Reconstruction of Long Mountain Road and Squire Hill Road
New Milford, CT

MMI #1481-53-06

ADDENDUM NO. 3

July 6, 2018

DRAWING NO.: PLN-03

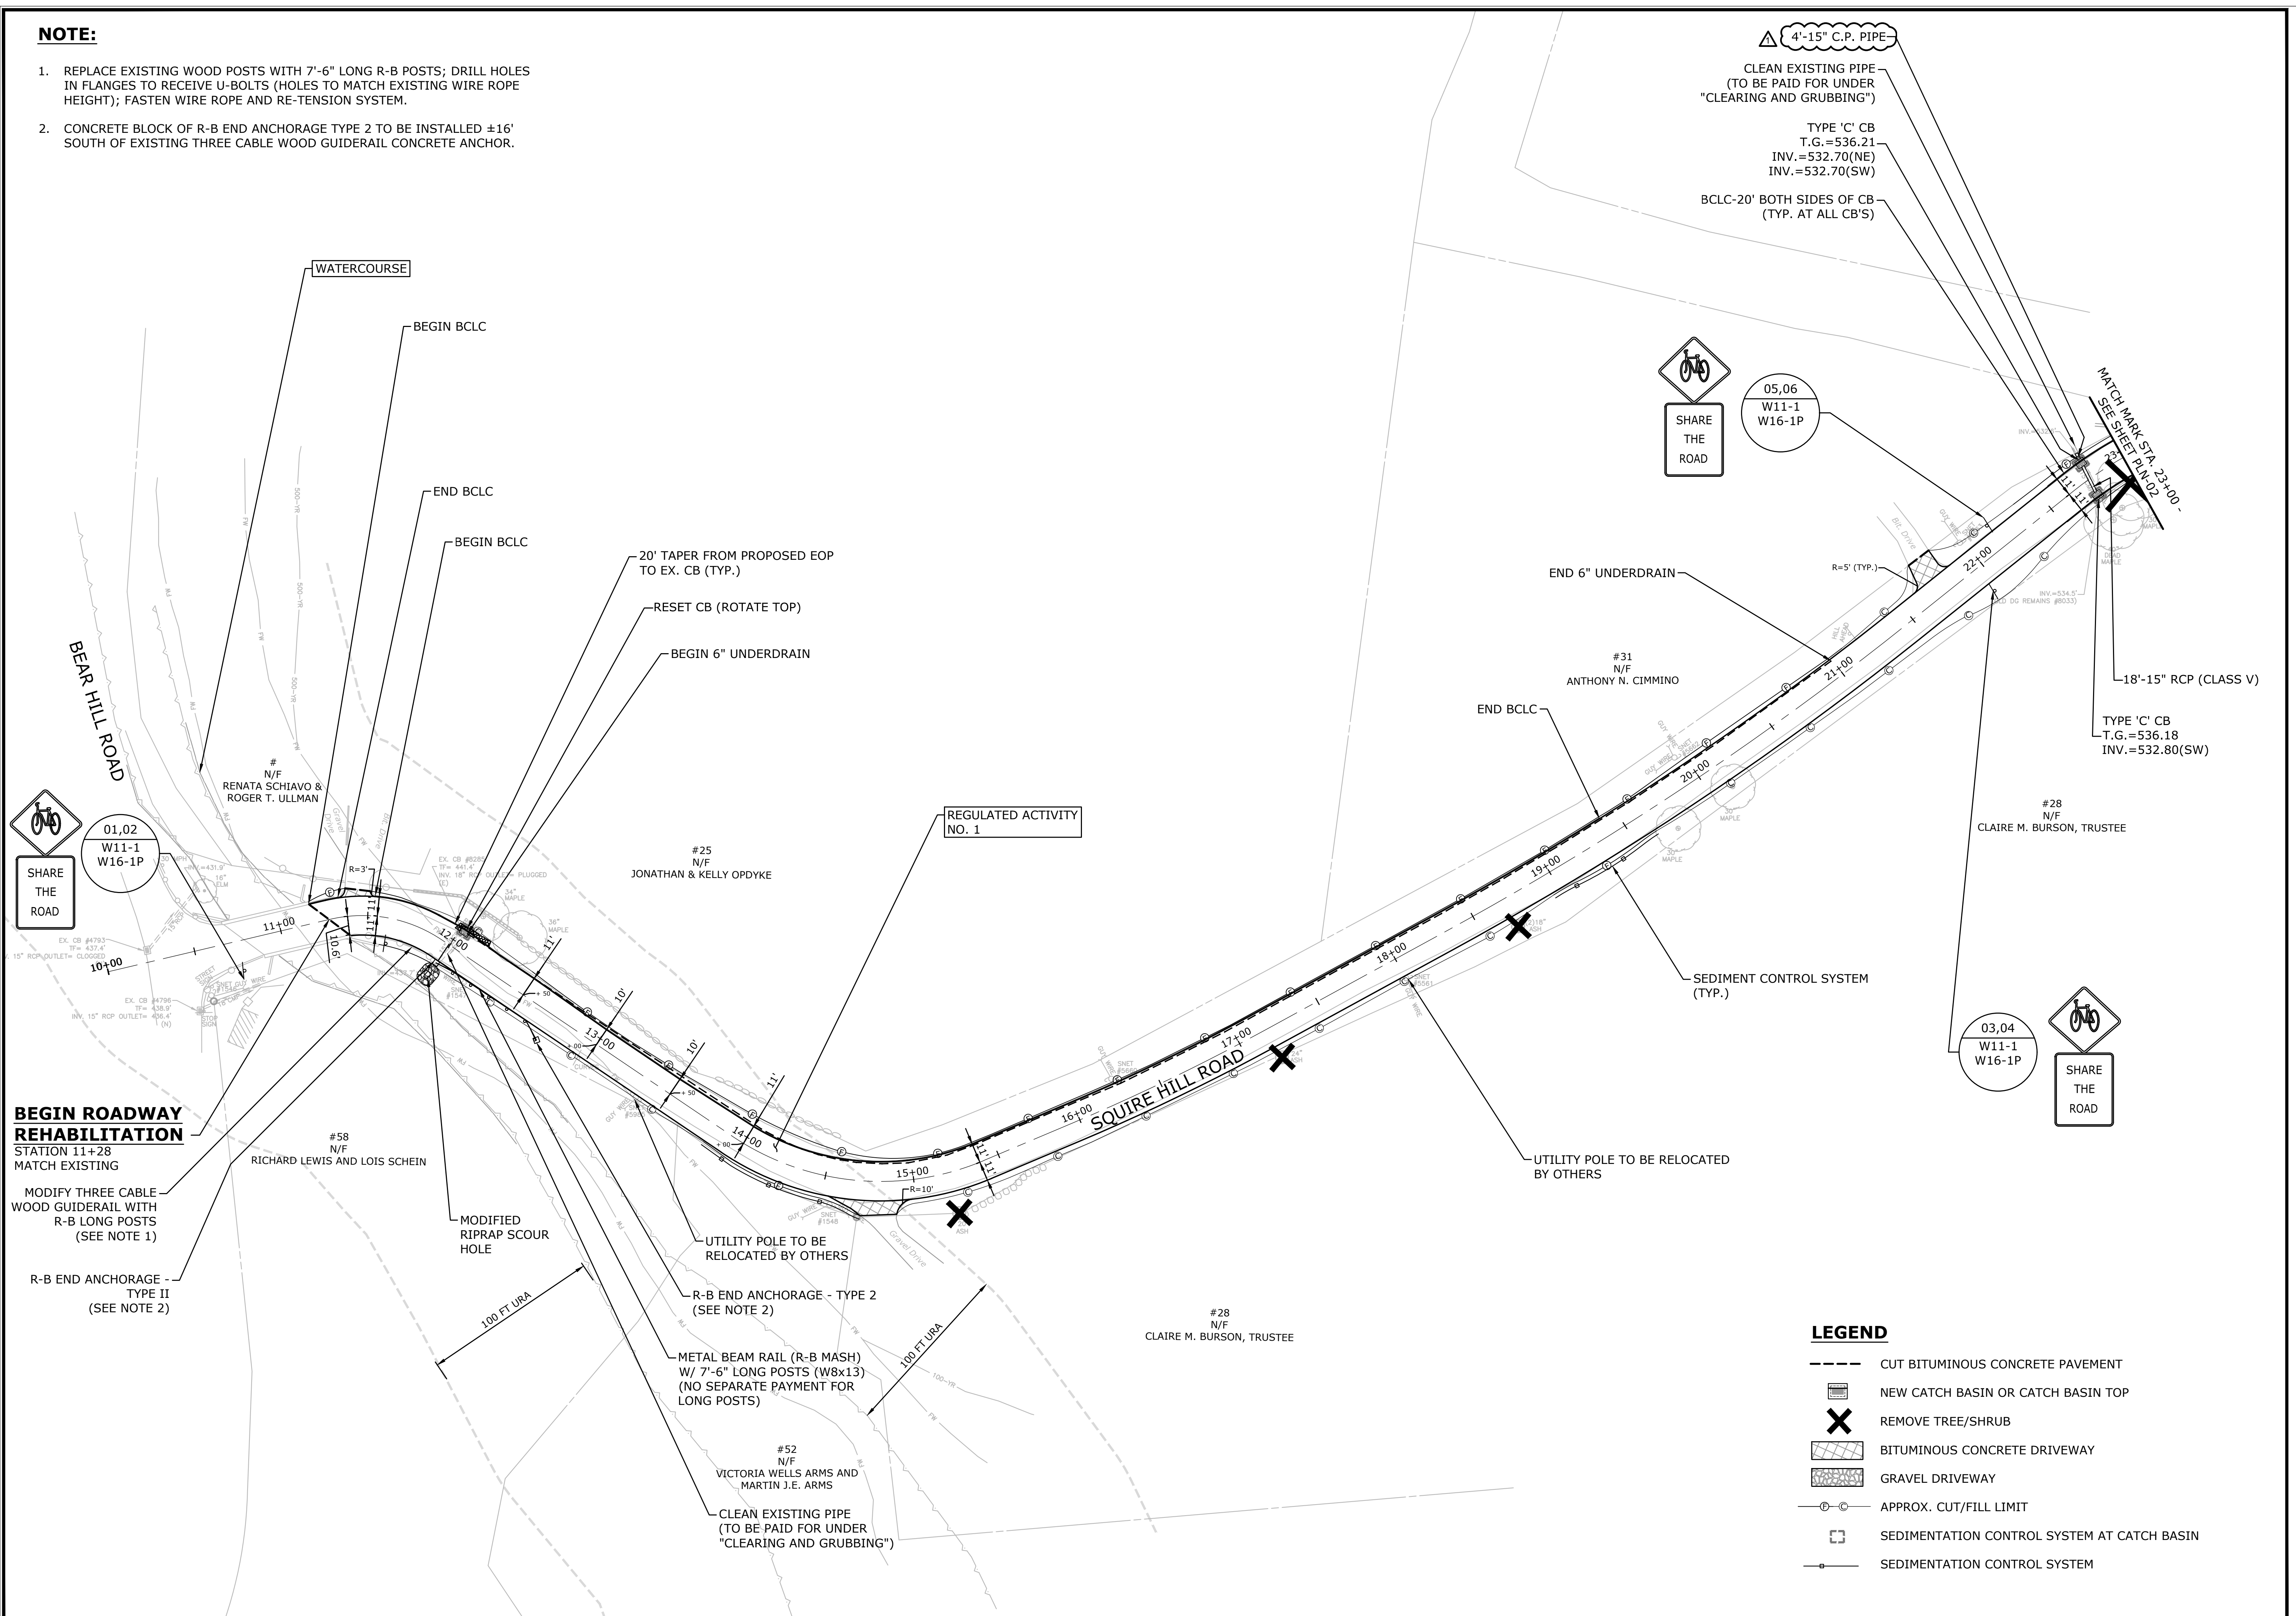
- Roadway Plan – Dwg. No. PLN-01 (Sheet No. 20)
4' – 15" R.C. Pipe at Sta. 22+80 Lt. has been revised to 4' – 15" C.P. Pipe.
Sheet No. 20 of the "Reconstruction of Squire Hill Road" plan set shall be replaced with Sheet No. 20A, attached.
- Roadway Plan – Dwg. No. PLN-03 (Sheet No. 22)
219' – 15" R.C. Pipe from Sta. 43+24 to 45+42 has been revised to 219' – 15" C.P. Pipe.
Sheet No. 22 of the "Reconstruction of Squire Hill Road" plan set shall be replaced with Sheet No. 22A, attached.

Question 2: It seems that an item for 15" Class IV RCP is missing. There are two locations, but the primary 220' run is on Squire Hill between ± 43+25 and 45+45.

Response: The pipe in question has been revised to 15" C.P. Pipe. Please see revisions above.
